Joint Regional Planning Panel (Sydney East Region)

JRPP No.	2011SYE075
DA No.	DA/494/2011
Local Government Area	Randwick City Council
Proposed Development	Construction of an 8-storey student accommodation development comprising 399 beds, ground floor retail units, basement car parking for 77 vehicles, landscaping and associated works.
Street Address	330 Anzac Parade, Kensington NSW 2033 (UNSW)
Applicant	Brookfield Multiplex Constructions
Owner	UNSW
Number of Submissions	Two (2) submissions
Recommendation	Approval subject to conditions
Report By	Simon Ip, Senior Planning Officer

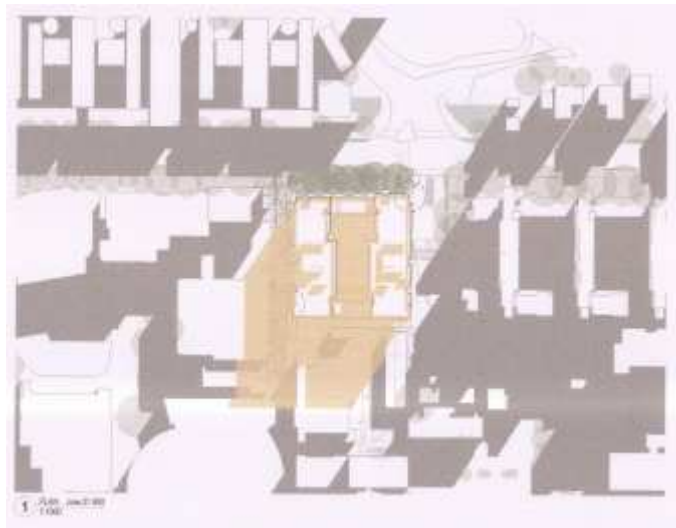
The entry ramp and the ramp leading to the lower level car park are located adjacent to each other and have safety implications. Council has requested the applicant to consider relocating one of the ramps to provide additional separation. However, the current design has not

The report has recommended the following measures to minimise potential traffic conflicts:

- Imposition of one-way traffic direction in the car park.
- Installation of signage indicating traffic direction.
- Provision of line marking to indicate traffic direction.
- Installation of convex mirror.

A specific condition is recommended to require the above measures are implemented in the development. Subject to the mitigation measures described above, the proposed parking design is considered to be acceptable.

Shadows at 9am, 21 June

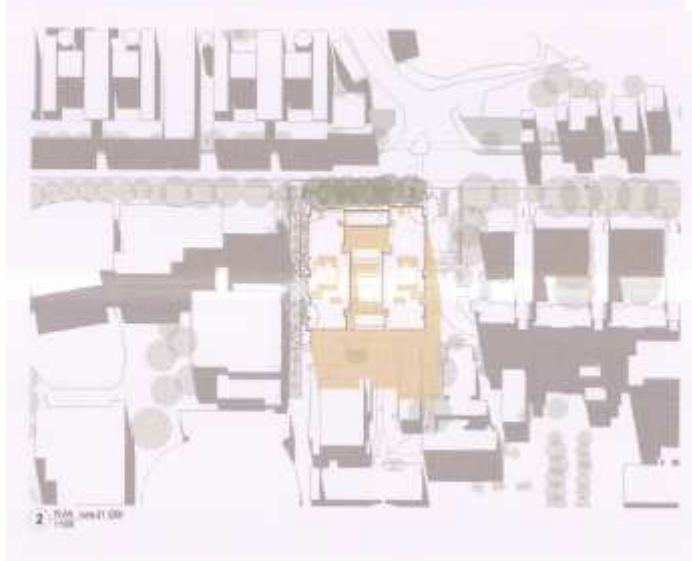
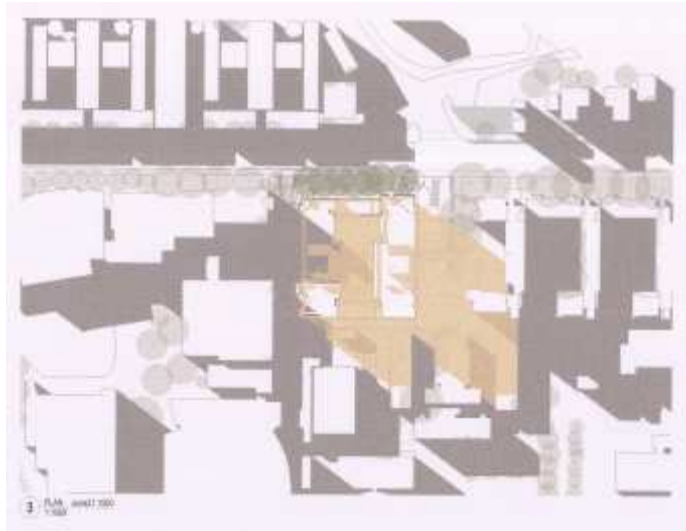
The proposed development will cast shadows on the eastern elevation of International House (residential college) to the west of the site at 9am, 21 June. The shadows will gradually shift away from the above residential college and by 12 noon no impacts will occur. The majority of the northern elevation of International House will receive a minimum of 3 hours of sunlight on 21 June.
